Re: 07V-476 All Document Submission

**VEHICLE SAFETY DEFECT SERVICE BULLETIN**  
**NHTSA Recall Campaign # 07V476**  
**Foretravel File # R07V-476**

**Re: Safety Recall – Villa Isri Air Base Seat**

**Subject:** Safety Recall #R07V-476-Villa Isri® Air Seat Base Tether

**NON SWIVEL SEAT INSTALLATION INSTRUCTIONS:**

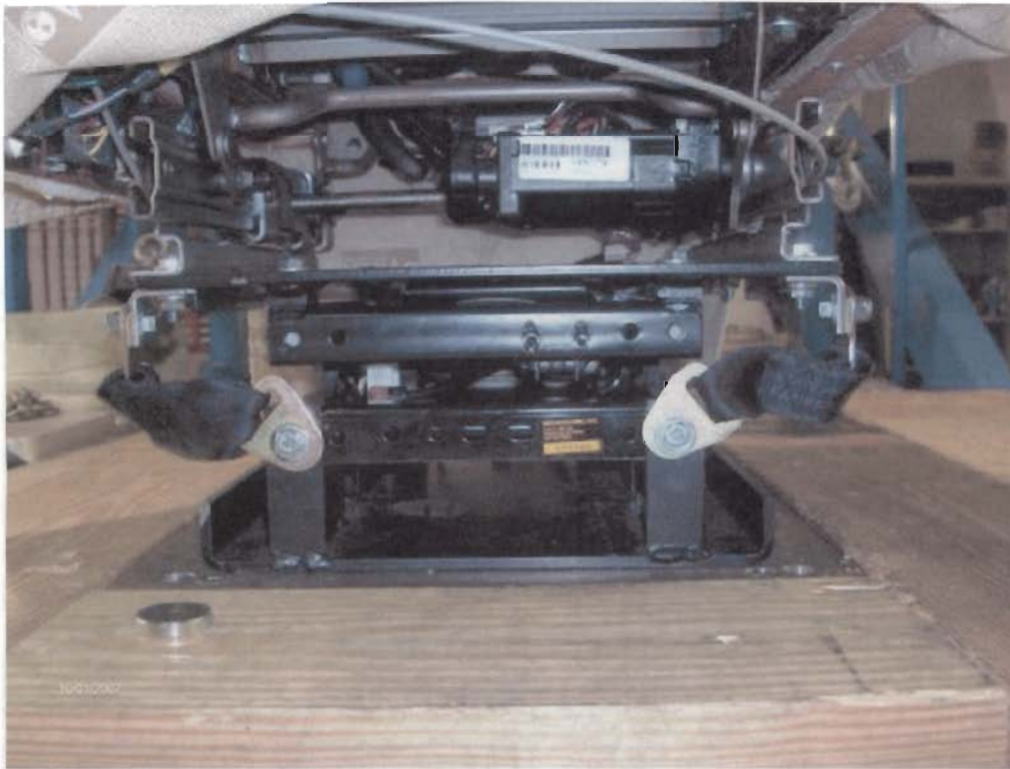
Assemble the brackets to the tethers with the 3/8" bolt head to the inside

Remove the nut and washer from the top front bolt. Install the bracket, reinstall the washer and nut on the bolt. Tighten the bolt and nut with two 1/2" wrenches.

The bottom bolt is a tight fit, but a ½" open end wrench will fit inside the channel to hold the nut. Angle the belt up at about a 30 degree angle as you tighten. Install the tether on the other side of the seat in the same sequence.

## SWIVEL SEAT INSTALLATION INSTRUCTIONS:

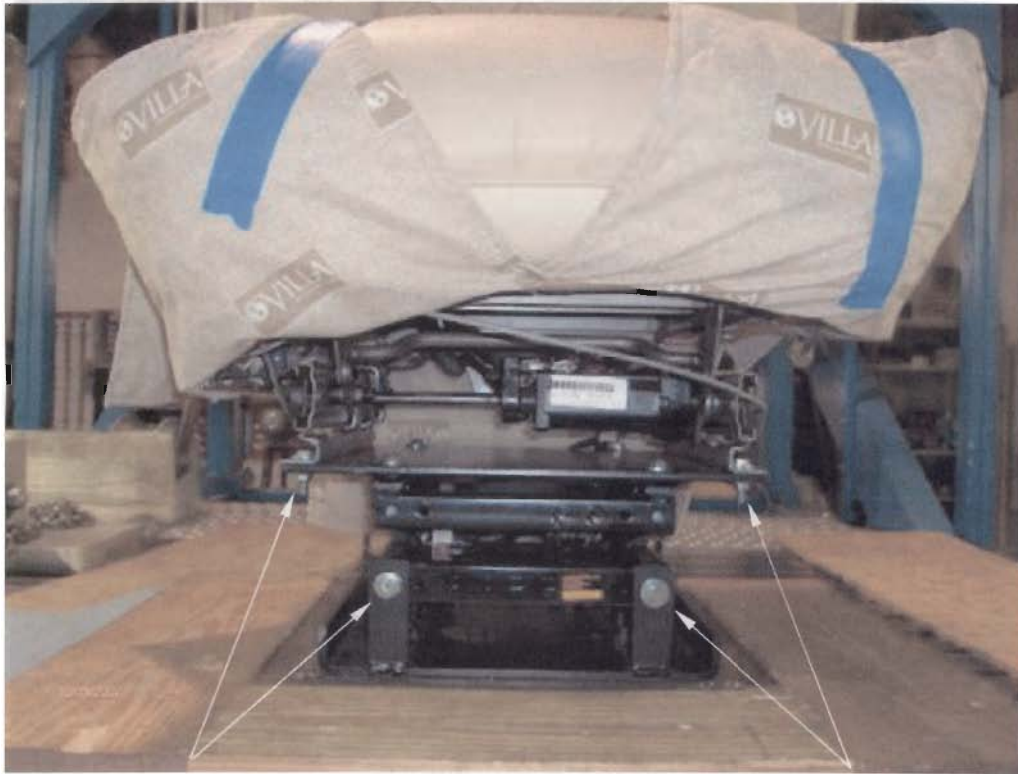
Pull skirt of seat up, and secure with masking tape. The tethers are attached from the adapter plate to the the top plate of the swivel riser.

Assemble the brackets to the tethers with the 3/8" bolt head to the outside.

## 22011 SWIVEL SEAT INSTALLATION INSTRUCTIONS:

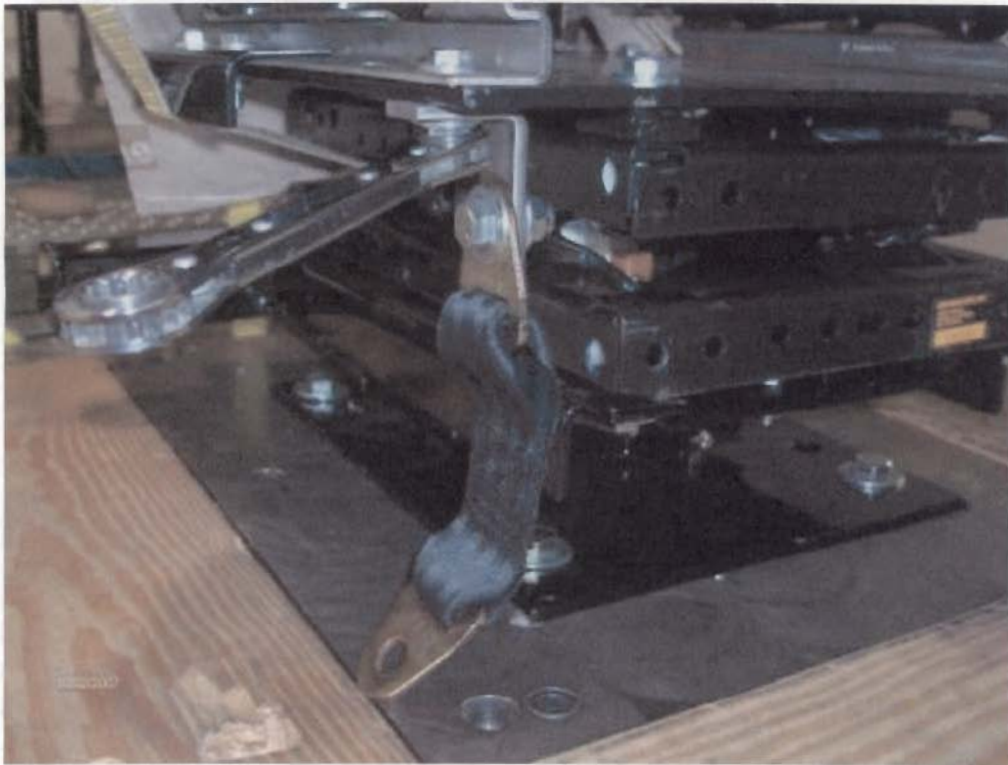
Pull skirt of seat up, and secure with masking tape. The tethers are attached from the adapter plate to the the top plate of the swivel riser.

Remove the nut and washer from the top front bolt. Install the bracket, reinstall the washer and nut on the bolt. Long leg of the bracket faces to the inside.

Remove the bolt and washer from the front of the riser and insert the tab from the tether

## SWIVEL SEAT INSTALLATION INSTRUCTIONS:

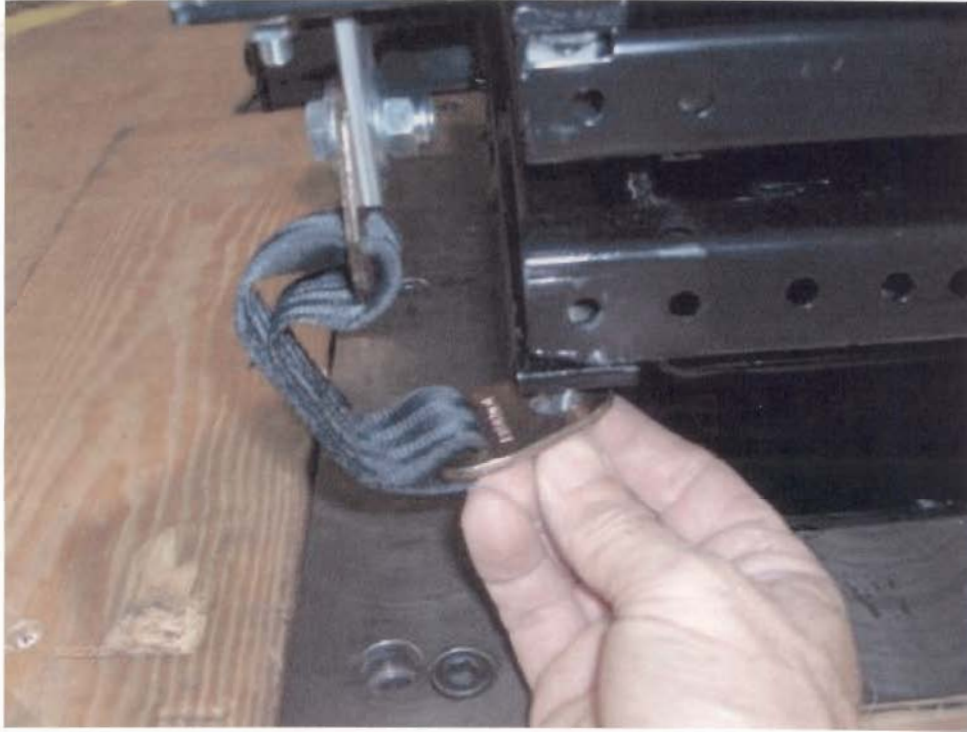
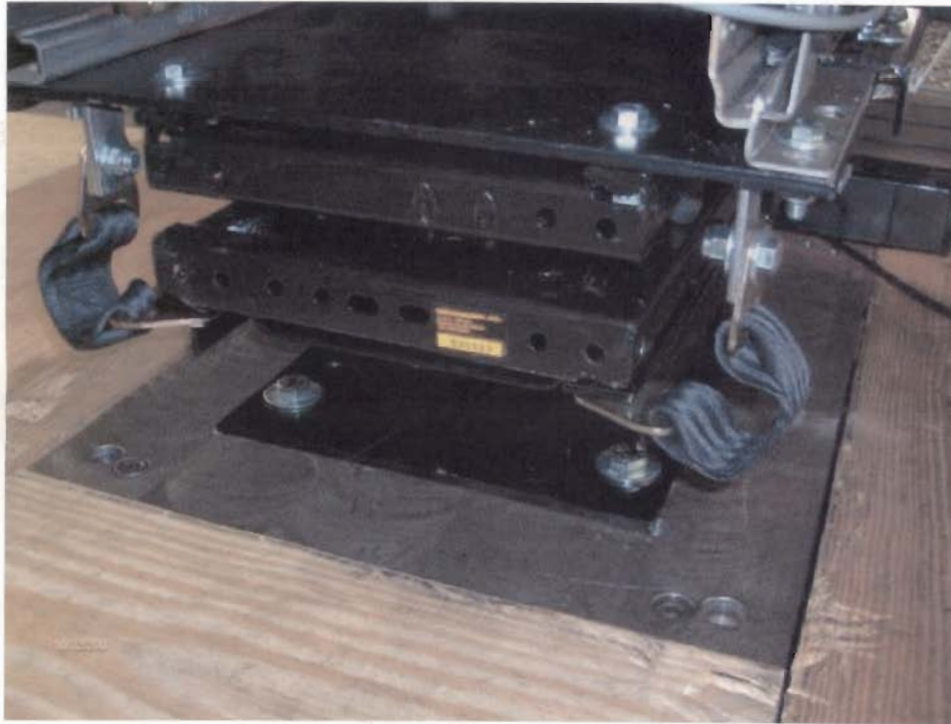
Reinstall bolt and washer with tether, and tighten. Install the tether on the opposite side of the seat in the same sequence.

This is the completed installation
